# HARTING Product Change Notification

Business Unit: Electronics PCN/21/037/C+N-US

Title: har-link shielding pins - PI Page 1/1

## **Details of the Product Changes**

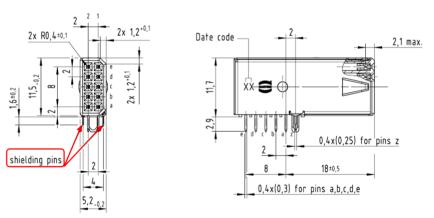
Shielding pins are shortened by 1.2mm to avoid pin bending during shipping and assembly.

This change has no impact on the technical characteristics or function of the product
